# AUBURN HILLS 3RD ADDITION

Re: S/D 96-83 - AUBURN HILLS 3RD ADDITION (Final Plat)

Re: S/D 96-83 AUBURN HILLS 3RD ADDITION (Final Plat)

**CASE NUMBER:** S/D 96-83 - AUBURN HILLS 3RD ADDITION

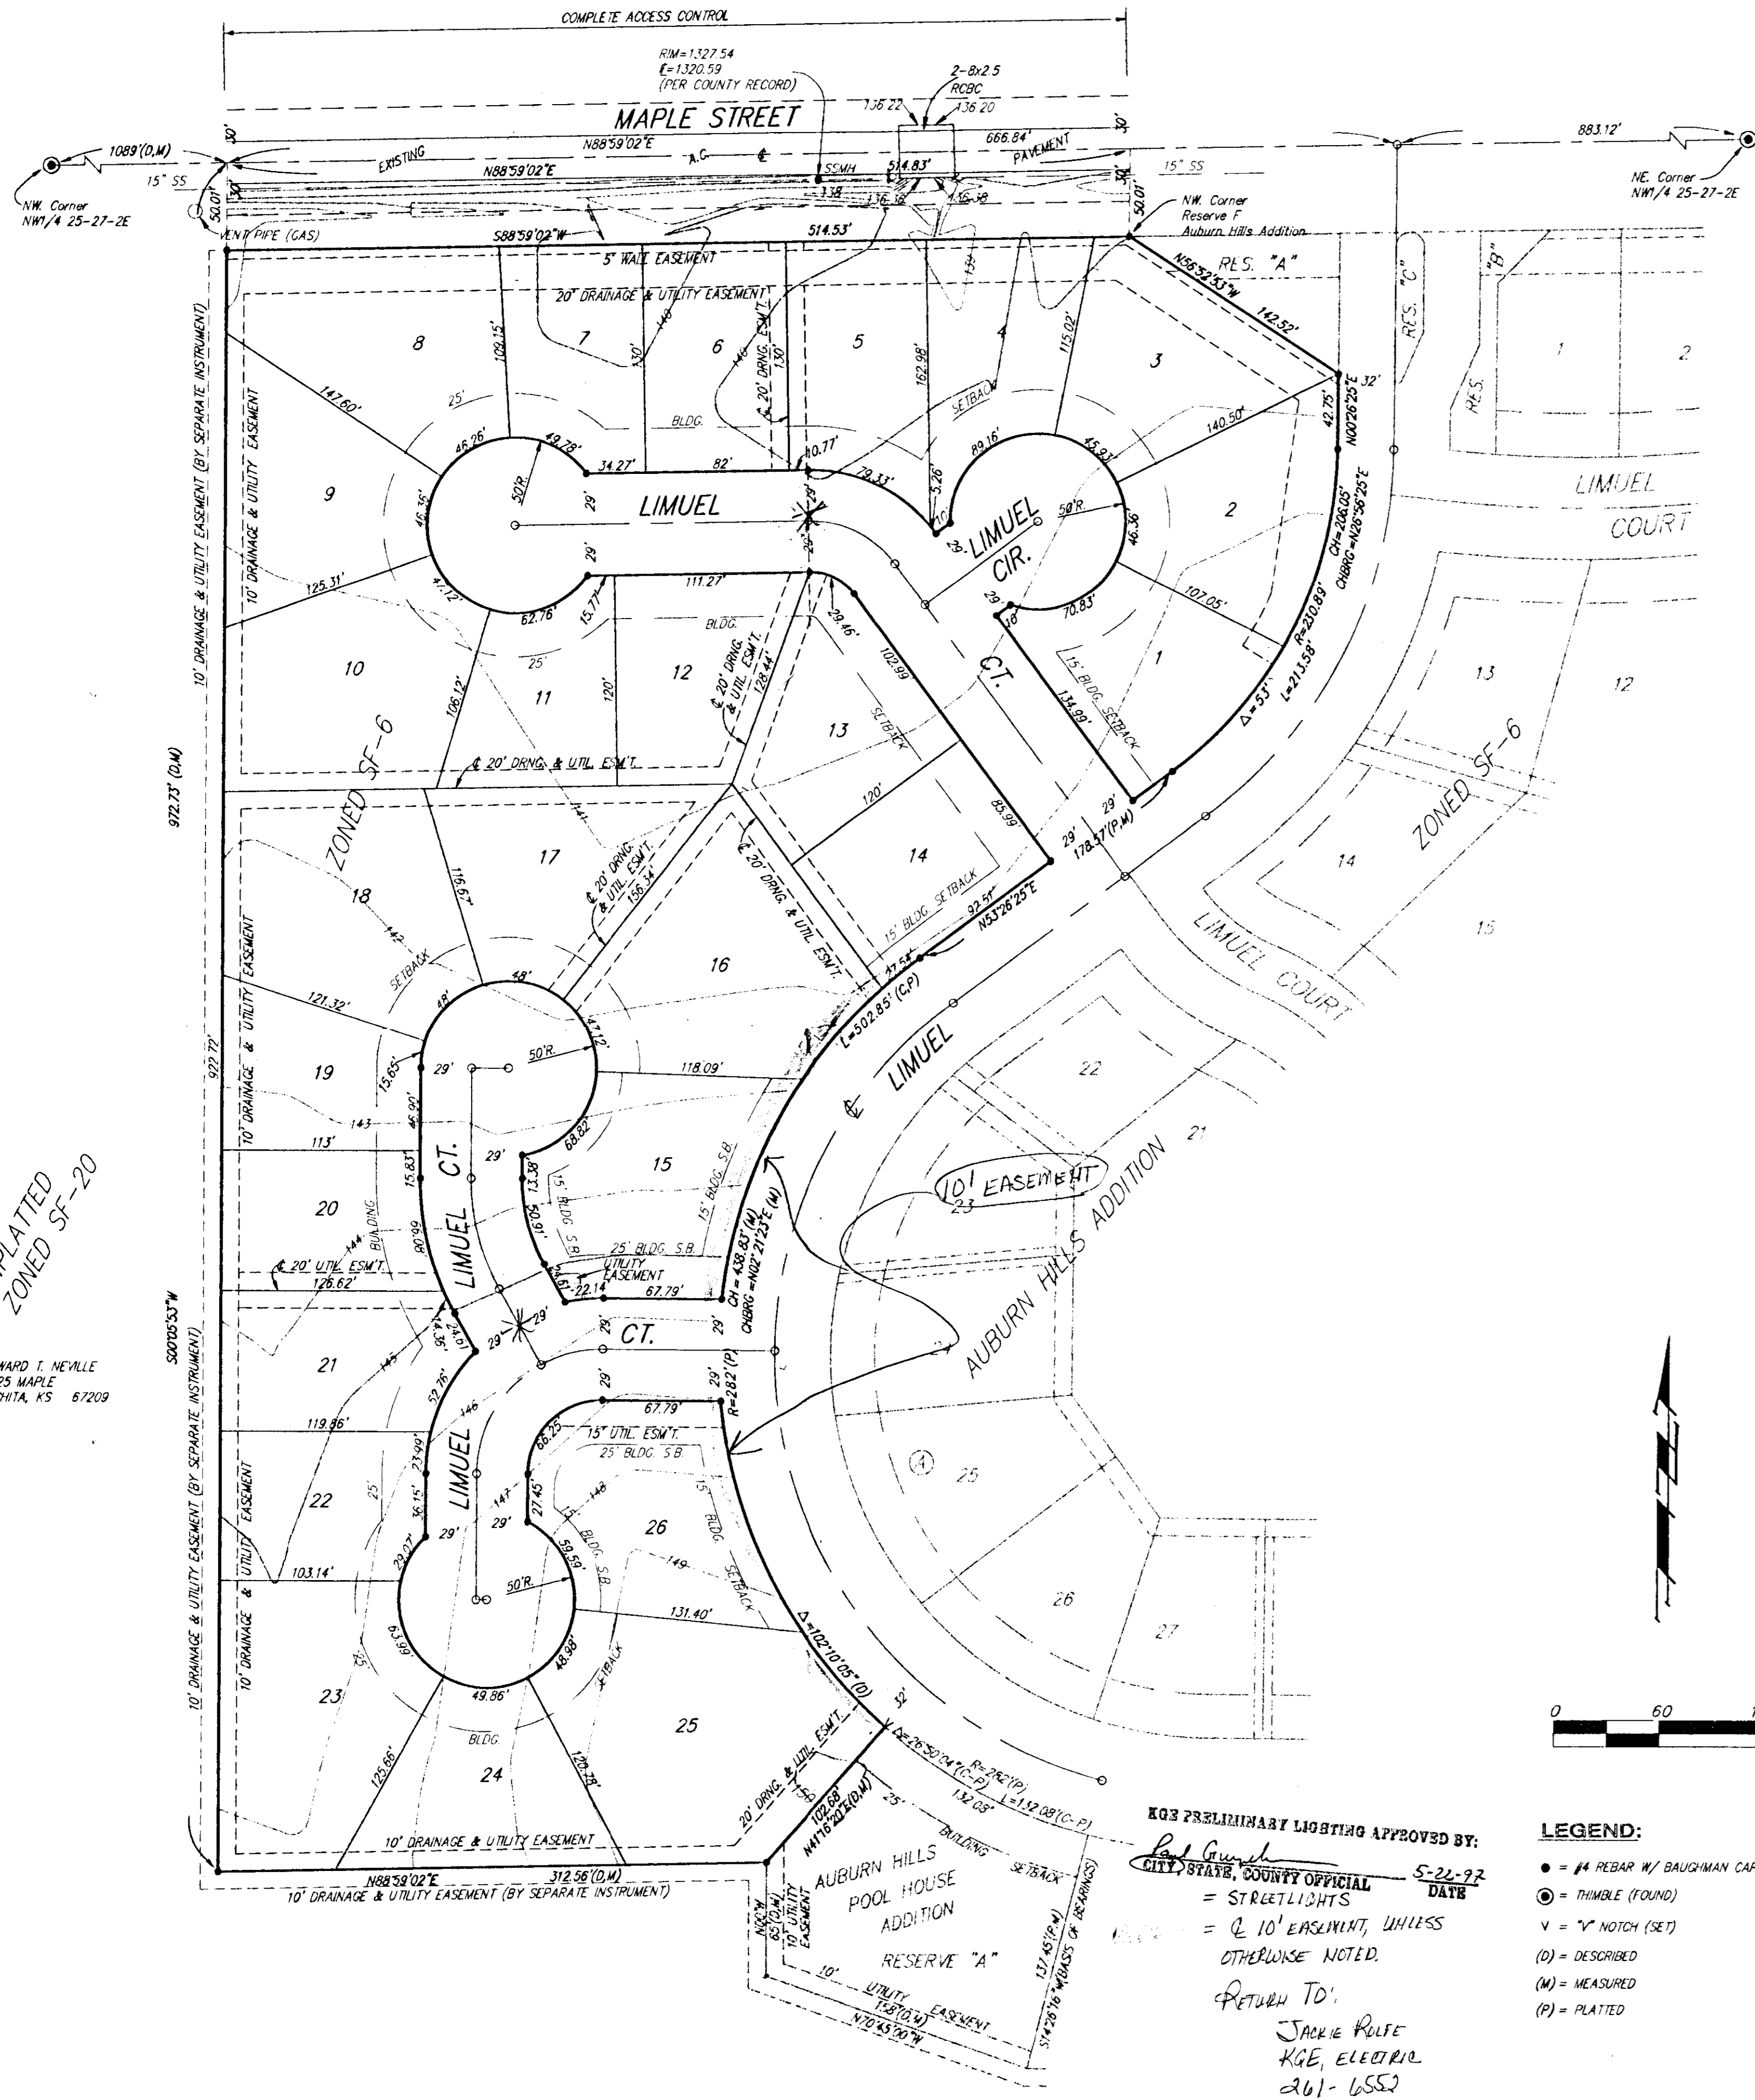
- H. On the final plat tracing, complete access control shall be shown to Maple from all abutting lots.

- R. The final plat tracing shall indicate the utility easements requested by K.G. & E. which are indicated on the enclosed "marked" copy of the plat.
- S. On the Final Plat Tracing, right-of-way for Maple shall be provided for 50-feet of 1/2 street right-of-way from this site. It appears that the 40-feet shown is not accurate and that 50-feet is the actual dimension. In any case, 50-feet shall be dedicated and properly shown.

- T. On the final plat tracing, the center line ("CL") of Maple shall be labeled.
- U. On the final plat tracing, the following amendments shall be made to the plattor's text.

5. Both the face of the plat and plattor's text has deleted reference to a wall easement along the site's north line. If a wall is still intended, both the face of the plat and plattor's text will need to indicate this. In regard to the 20-foot easement now being shown, any 5-foot wall easement would need to be platted exclusive of any other such easements (utility, drainage, etc.). That is a 20-foot utility/drainage easement, with an adjacent 5 ft. wall easement would need to both be shown.

- V. Since this is a plat of unplatted property, the reference to K.S.A. 12-512(b) in the Surveyor's text is generally not appropriate unless public reservations by separate instruments are involved. However, the platting indicates that no separate instruments are involved on this site.

- W. In regard to W. Kent, the prefix "W" does not appear to be appropriate. Kent exists to the east of this site (1/2 mile) but is only found in this area. That is, there is no "E" side Kent and the use of "W" Kent may imply a new, different Street. The "W" therefore shall be deleted. Also, the "eyebrow" court coming off of Kent as shown is not a circle, and if distinctly named, should be labeled as a Court (a Kent Ct.)

- Y. Also, the plat binder indicates that the State Bank of Colwich holds a mortgage on this site. This party shall therefore be shown on the plat as a signatory.
- Z. On the final plat tracing, "Deputy" shall be deleted from the City Clerk's signature block.
- AA. On the final plat tracing, additional information shall be shown for street right-of-way. Both the width of Limuel Court along the spine of this street and the radius of the turnaround need to be shown.

For Kent, additional street right-of-way dimensions need to be shown for this street's entrance from Limuel and for the Court area that surrounds Reserve "D". If necessary, separate distinct drawings of these areas may need to be added to the final plat tracing.

- BB. On the final plat tracing, the indicated tiepoint to the N.E. corner of the N.W. 1/4 (quarter) needs to reference range 2W not 2E.
- CC. Also, the tying of this site to a Reserve in the Auburn Hills (1st) Addition, at the northeast corner of this plat, should correct the involved Reserve as being Reserve "A" not "F".

- DD. On the final plat tracing, appropriate dimensions shall be shown for the building setbacks of corner lots. Specifically, Lots 20 and 25, Block 1, shall indicate a 15-foot building setback to Limuel. Lot 1, Block 2 also needs to indicate additional dimensions to better describe the setback being shown to Limuel.
